**NOTICE TO ALL CONTRACTORS:**

**Proposal #58: 1517-07-74**  
**USH 10 – USH 10/STH 441**  
**County CB – Oneida Street**  
**I-41 (STH 441 - CTH II)**  
**USH 10**  
**Winnebago County**

**Letting of May 10, 2016**

This is Addendum No. 04, which provides for the following:

Addendum No. 04  
 ID 1517-07-74  
 Revised Sheet 37  
 May 3, 2016

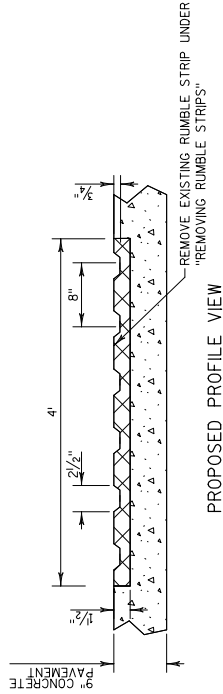
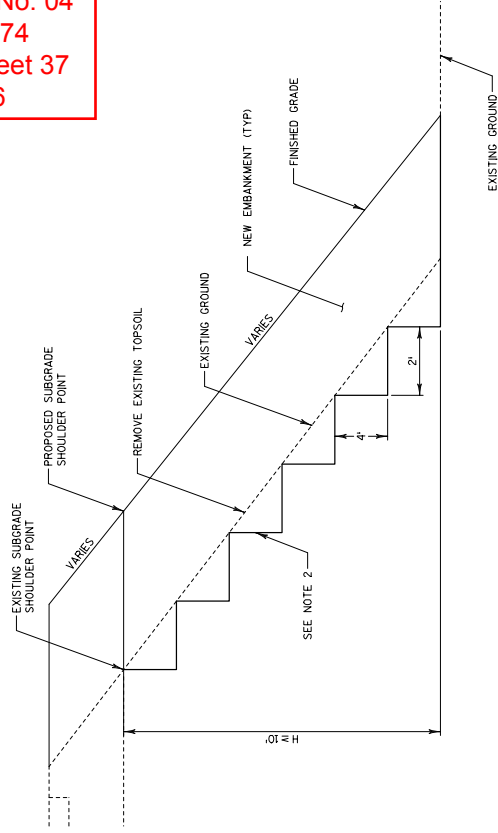
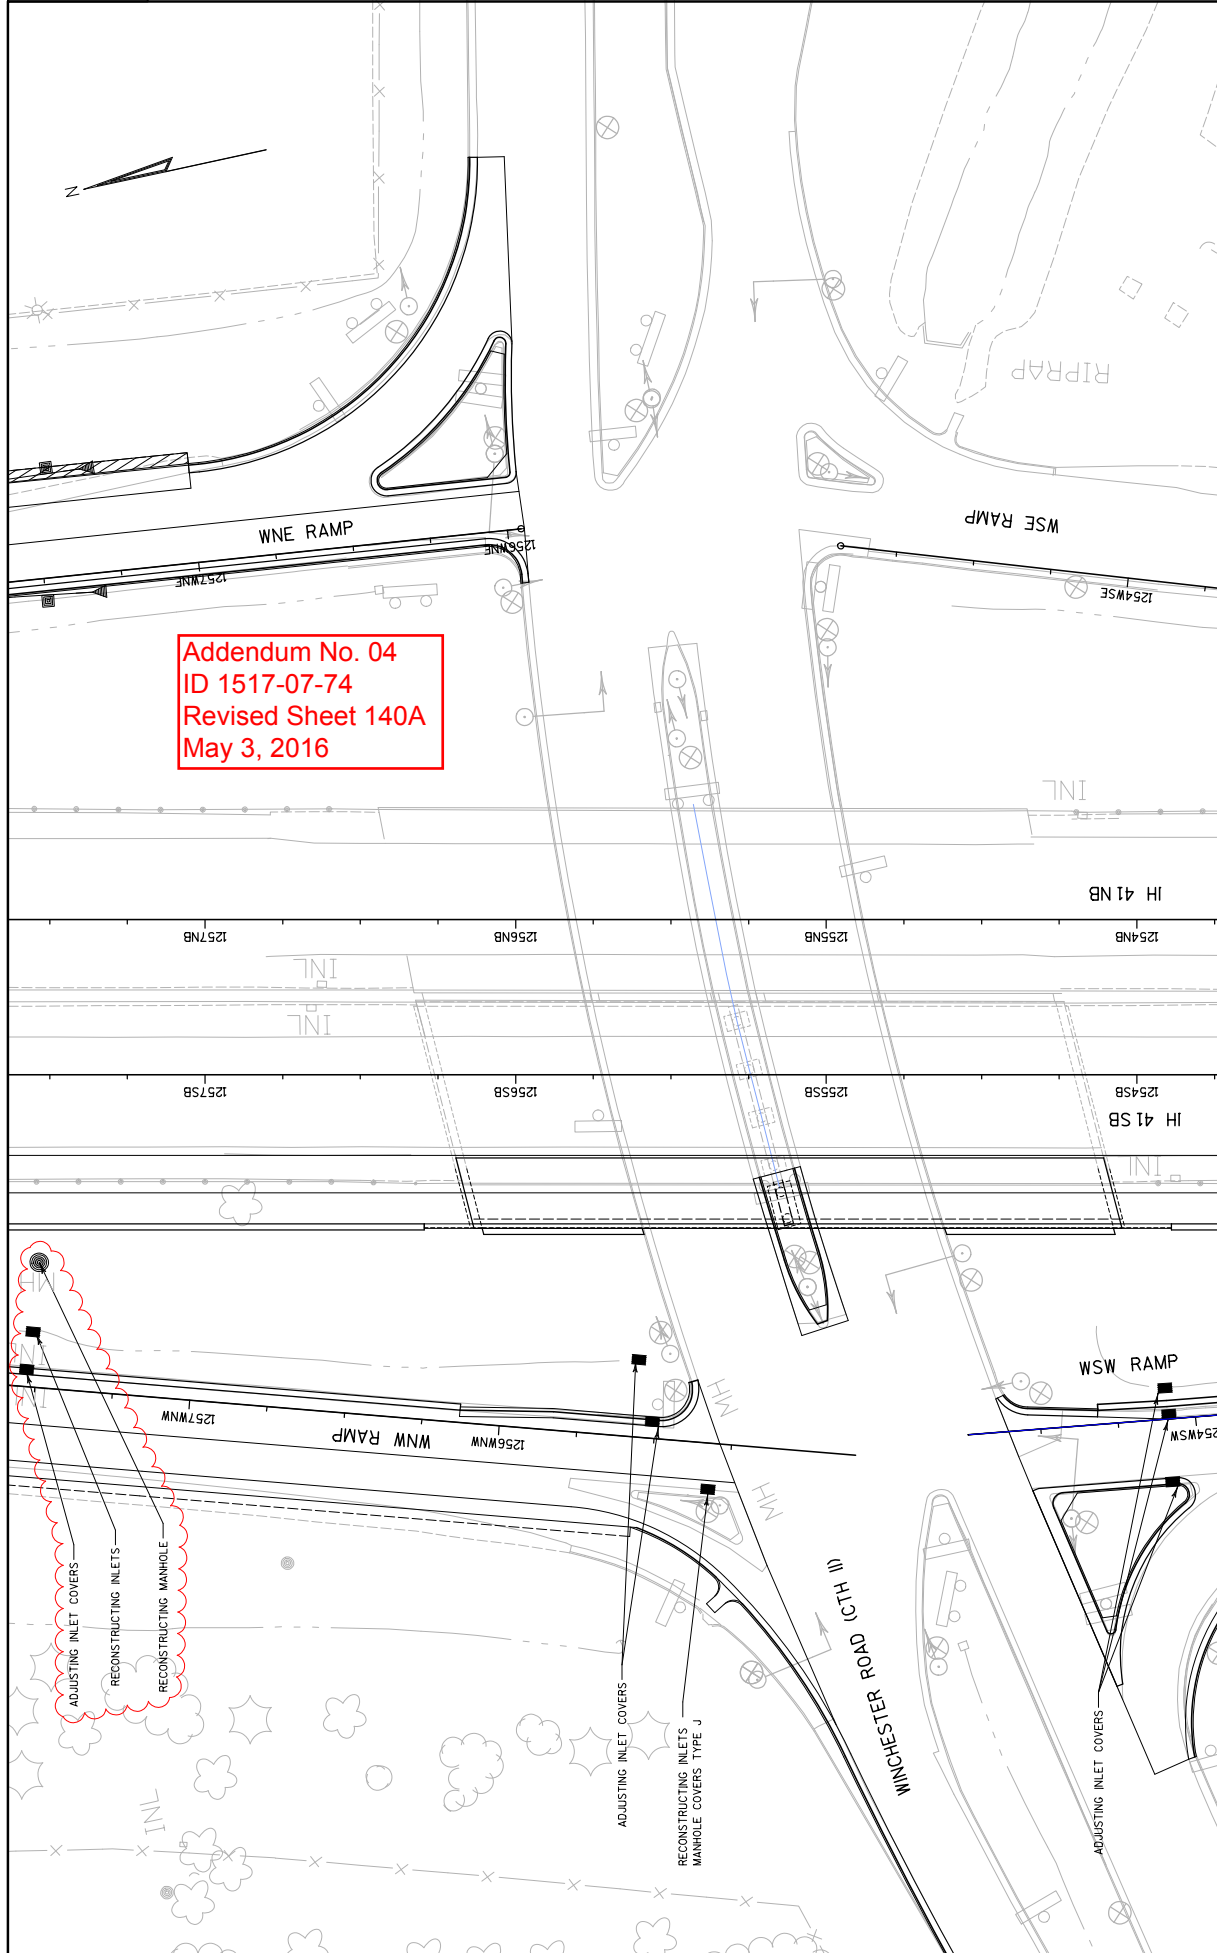
Revised Plan Sheets	
Plan Sheet	Plan Sheet Title (brief description of changes to sheet)
37	Construction Details (change removing rumble strips to 36" wide Mill)
140A	Storm Sewer (Added reconstructing inlets call out)
187B	Traffic Signal (updated plan loop detection)
187C	Traffic Signal (updated plan loop detection)
187D	Traffic Signal (updated plan loop detection)
268	Miscellaneous Quantities (updated removing rumble strip quantities)
269	Miscellaneous Quantities (Added quantities for loop 21 & 61 pavement removal)
270	Miscellaneous Quantities (Added adjusting storm sewer quantities)
271	Miscellaneous Quantities (Updated Earthwork)
273	Miscellaneous Quantities (Updated 7-Inch Pavement)
277	Miscellaneous Quantities (Added missing storm sewer quantities)
281	Miscellaneous Quantities (updated traffic control quantities)
283	Miscellaneous Quantities (updated landscaping quantities for Pond 6)
285	Miscellaneous Quantities (Added single lane and two lane closures for stage 3 for overlays)

PLACE HMA PAVEMENT 4 MT 58-28 S FLUSH WITH REMAINING SHOULDER. PAY LIMITS ARE AREA OF EXISTING RUMBLE STRIP. PAID UNDER "REMOVING RUMBLE STRIPS".

Addendum No. 04  
 ID 1517-07-74  
 Revised Sheet 317  
 May 3, 2016

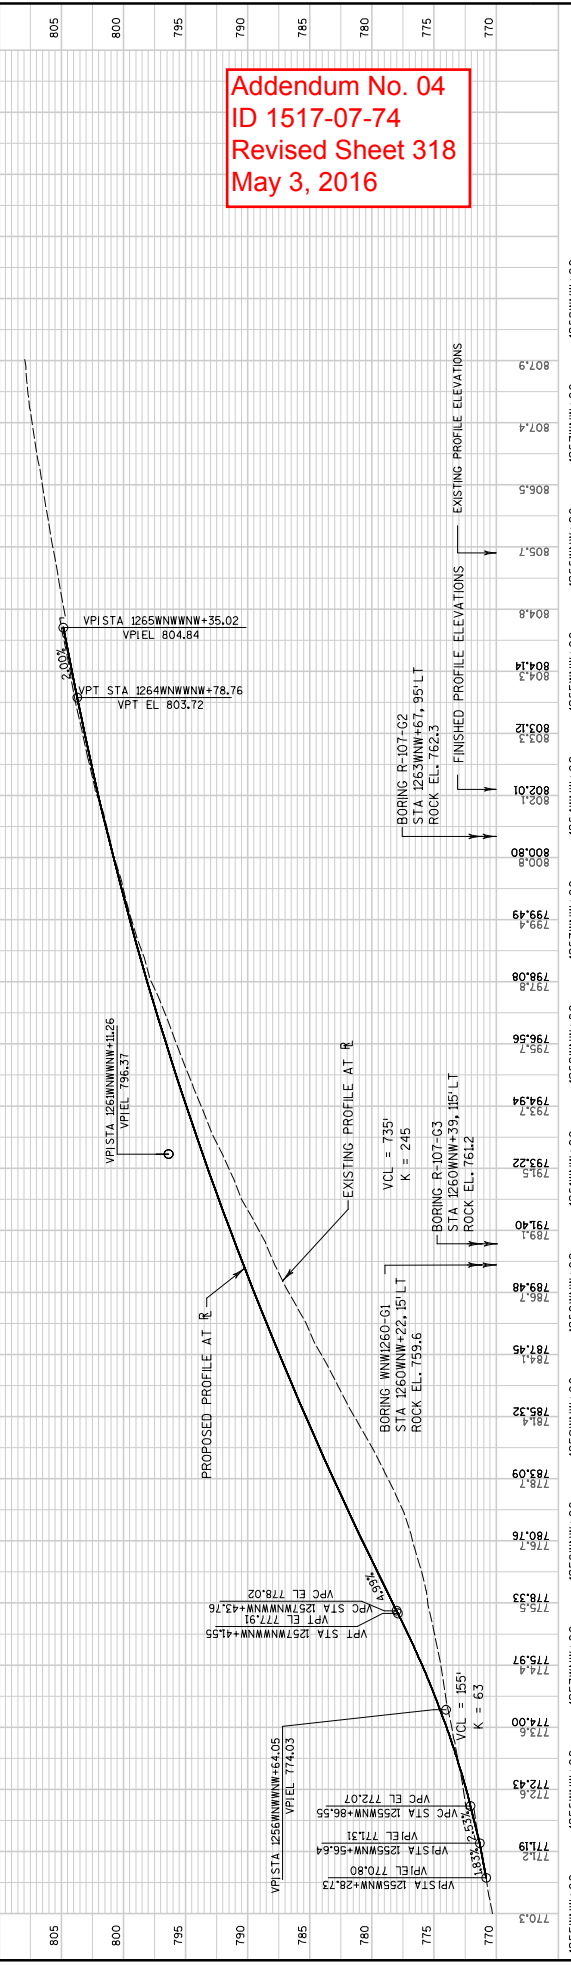
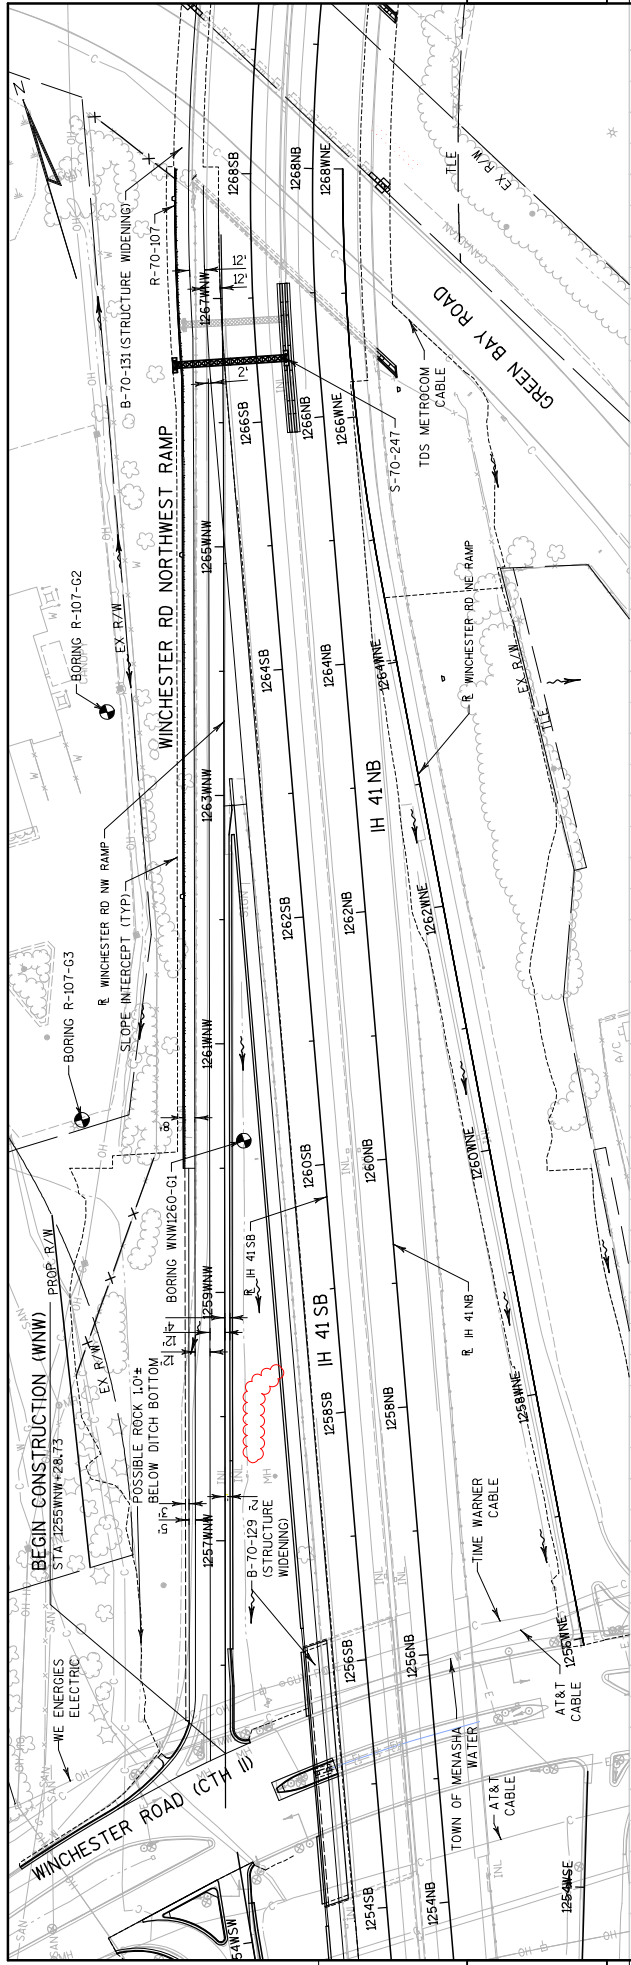
290	Miscellaneous Quantities (Added quantities for loop 21 & 61 pavement repair)
301A	Miscellaneous Quantities (Added quantities for pull boxes)
301B	Miscellaneous Quantities (Added quantities for loop detection)
317	Plan & Profile (removed note that referenced a wall that does not exist)
318	Plan & Profile (removed note that referenced a wall that does not exist)

Addendum No. 04  
ID 1517-07-74  
Added Sheet 345E  
May 3, 2016

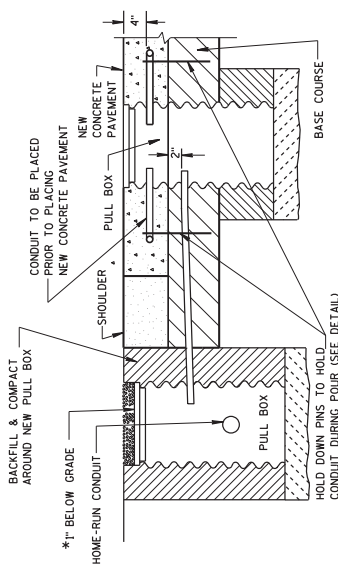
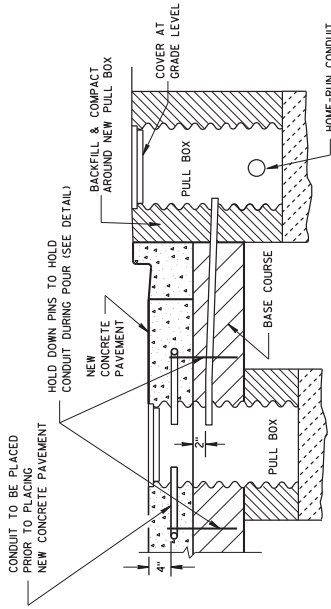
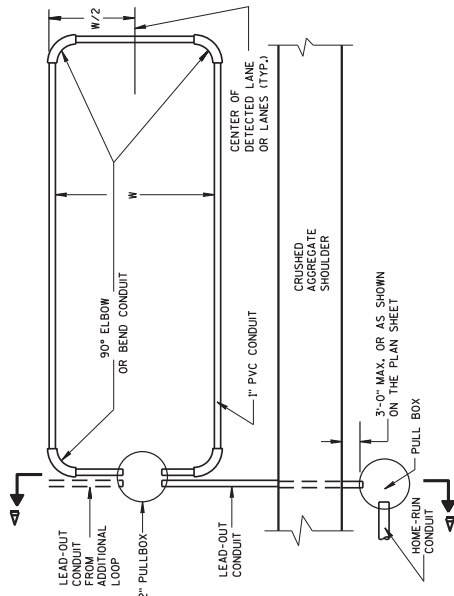
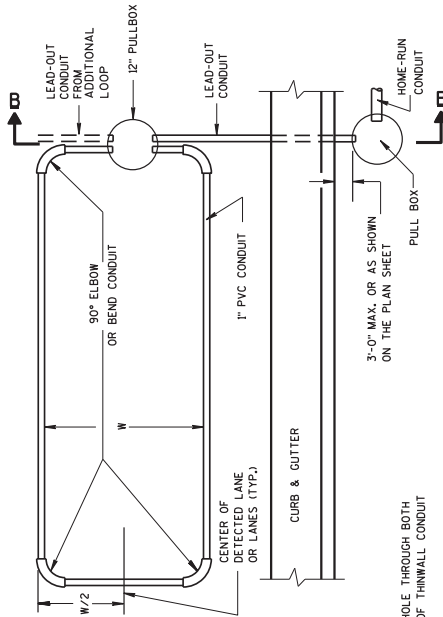
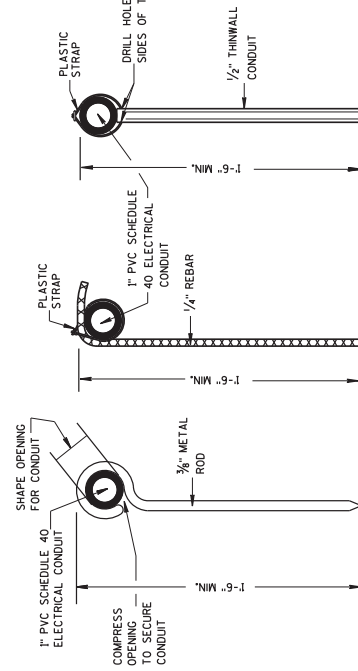
<b>Added Plan Sheets</b>	
Plan Sheet	Plan Sheet Title (brief description of why sheet was added)
277A	Miscellaneous Quantities (Added in missing storm sewer quantities)
345E	SDD – Loop Detector Installed in New Concrete Pavement Round CSCP Pullbox
345F	SDD – Loop Detector Installed in Base Course with Pull (Splice) Box Off Roadway (Option 1)
